Re: Answers to questions from E-mail of 04/05/00
Correspondence Reference Number: 13281
FCC ID: H25DSS950TX
731 Confirmation Number EA96934
Equipment Class: DSS-Part 15 Spread Spectrum Transmitter
Applicant: DTC

DTC has collected additional data on H25DSS950TX in order to satisfy all six questions on the referenced E-mail.

EXHIBIT 1 PHOTOS

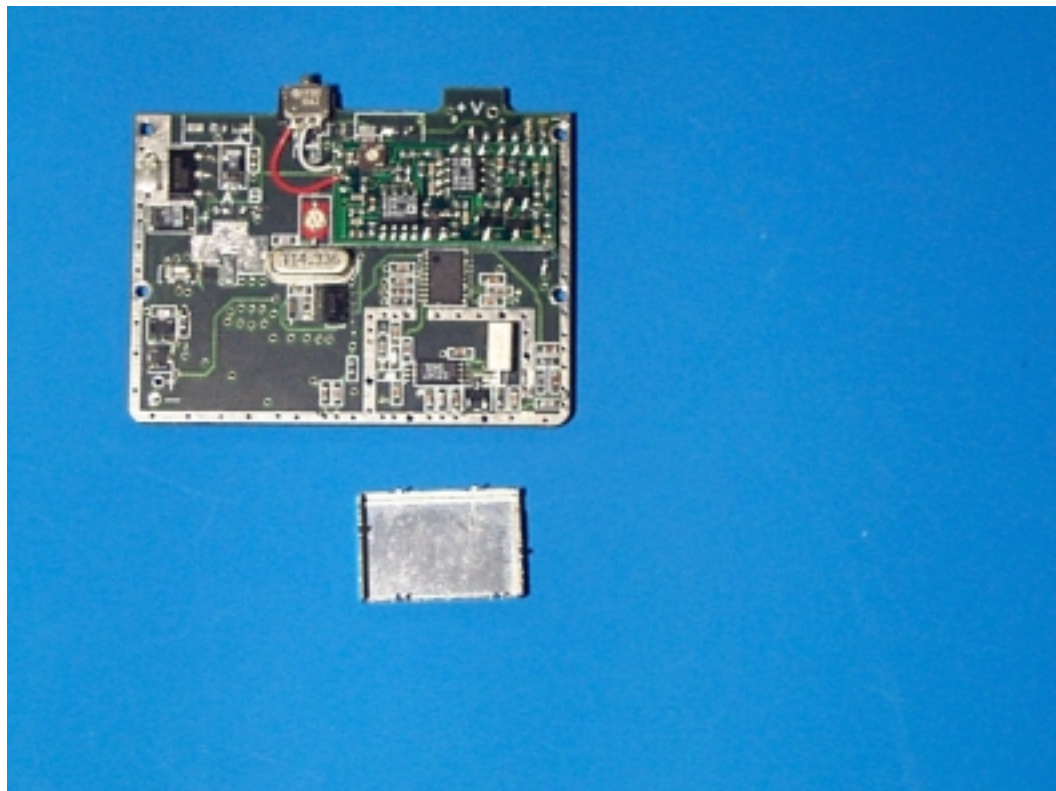
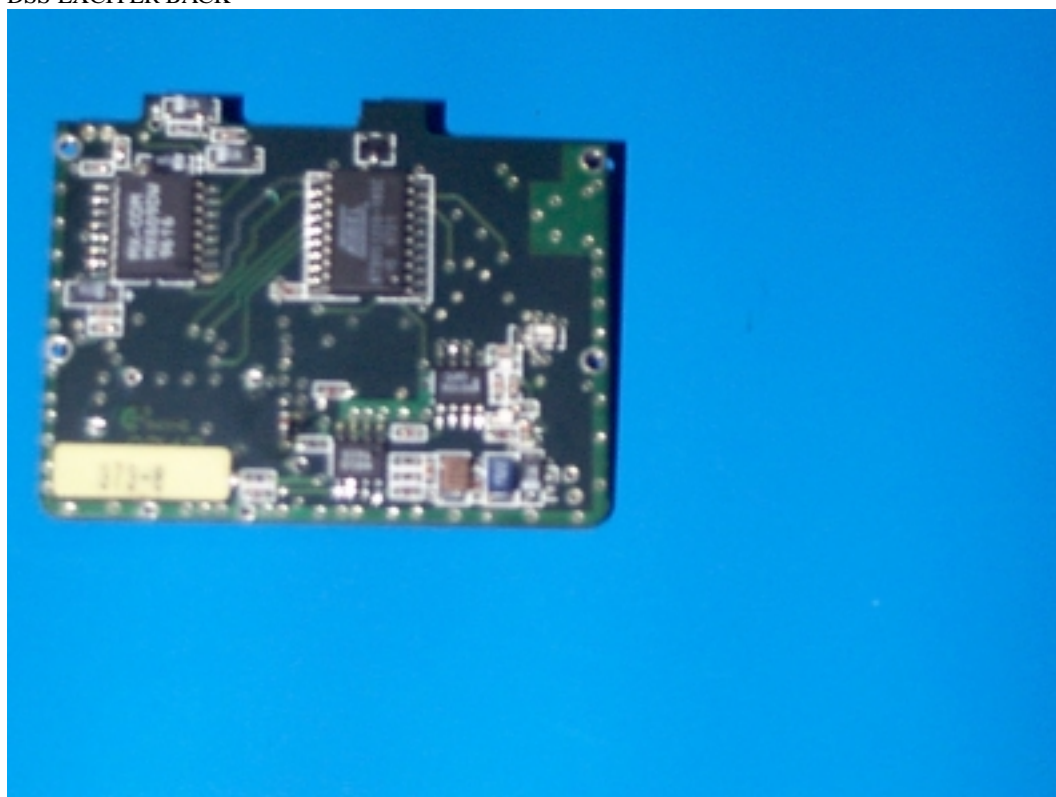
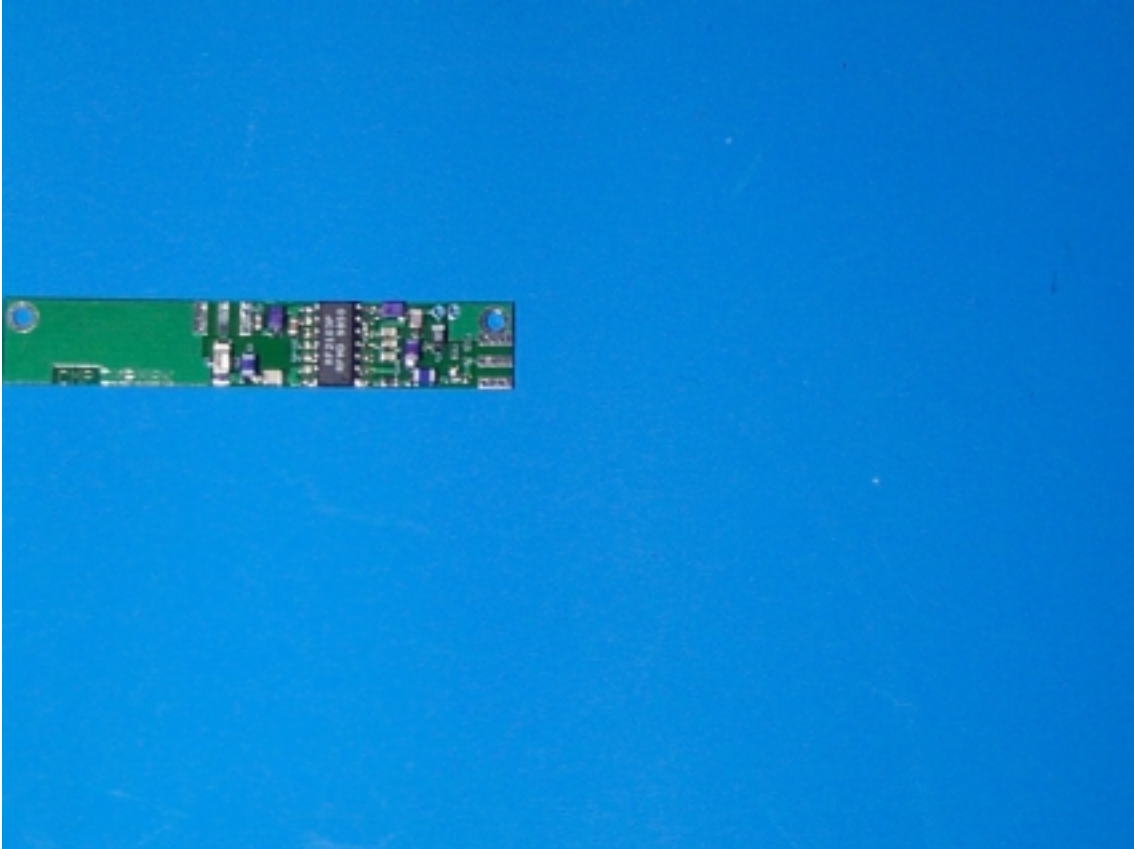
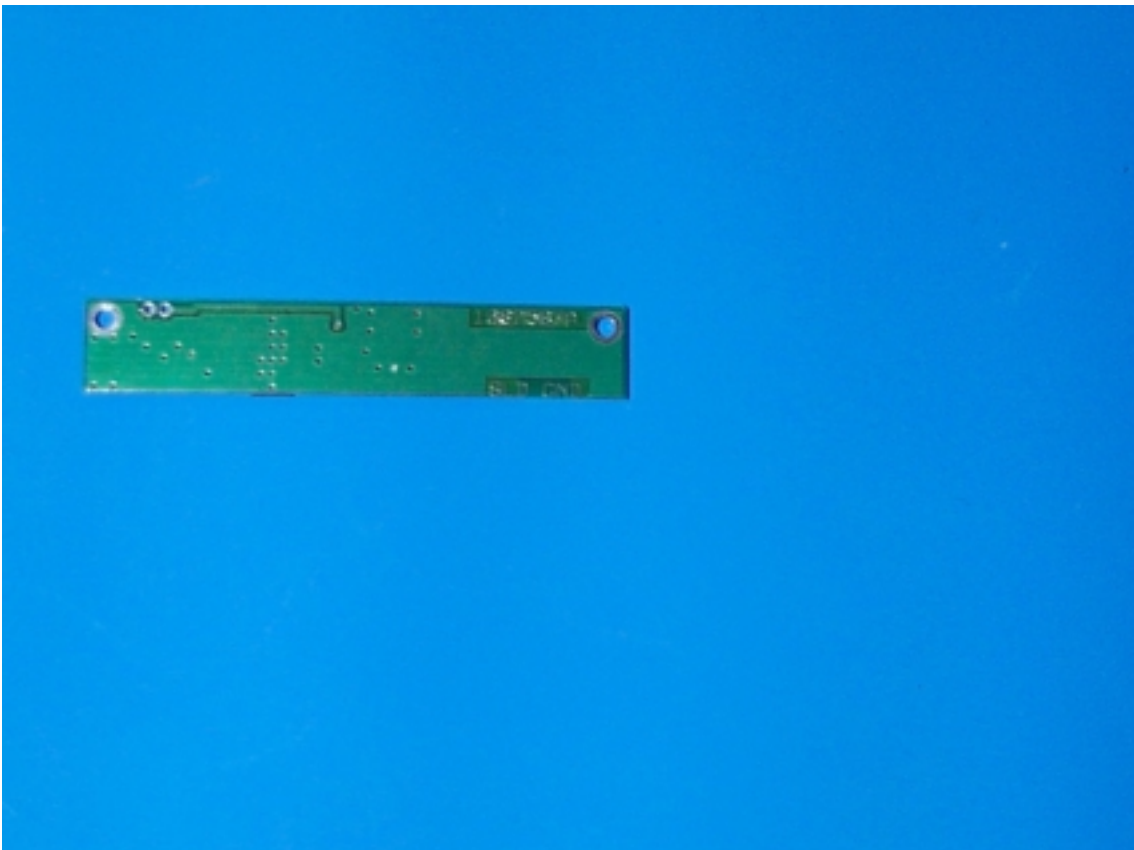
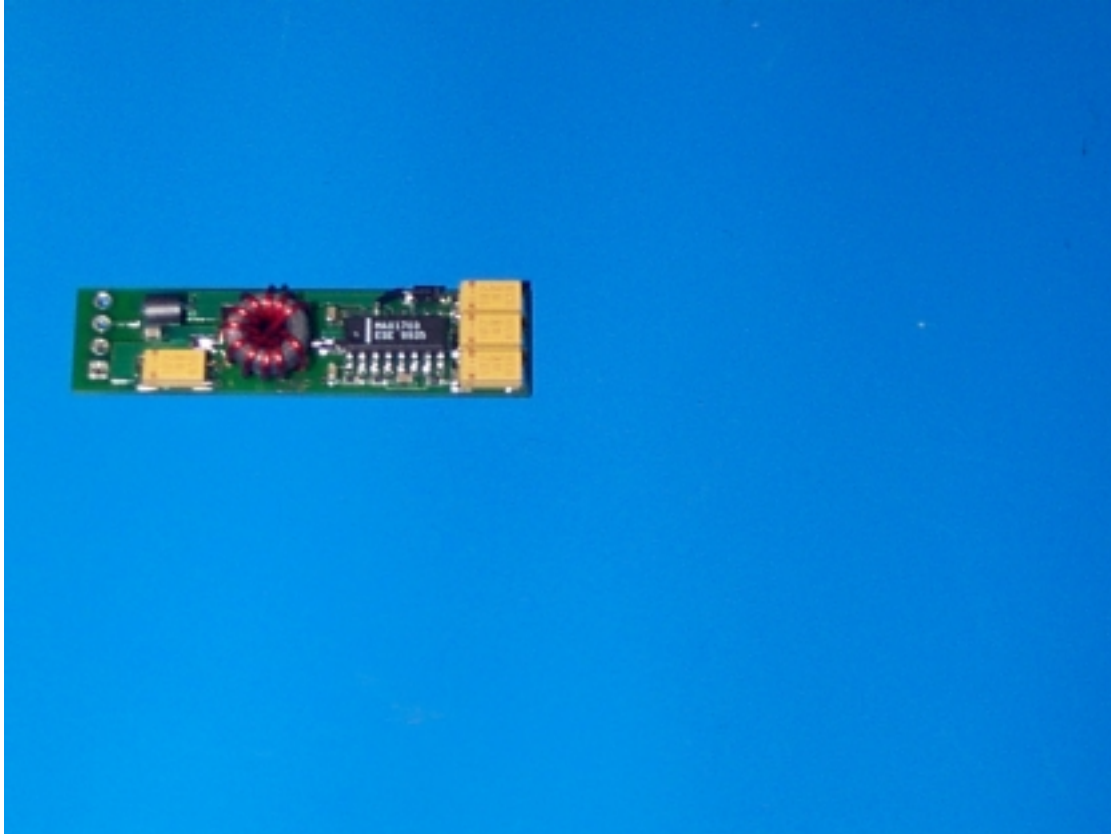
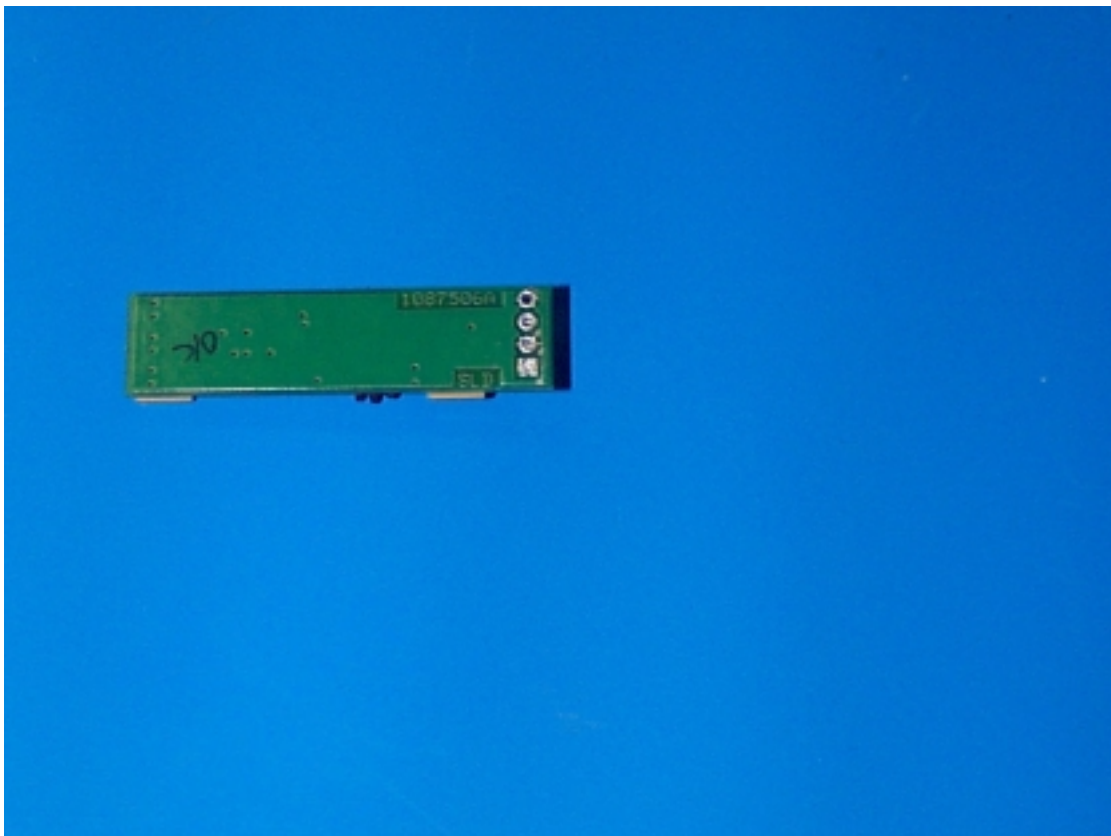
1. The antenna gain of the integral patch antenna on the DSS950TX is 2 dBi.
2. Additional photos have been taken of all three boards; front and back with all shields removed. These are attached to this document as EXHIBIT 1.
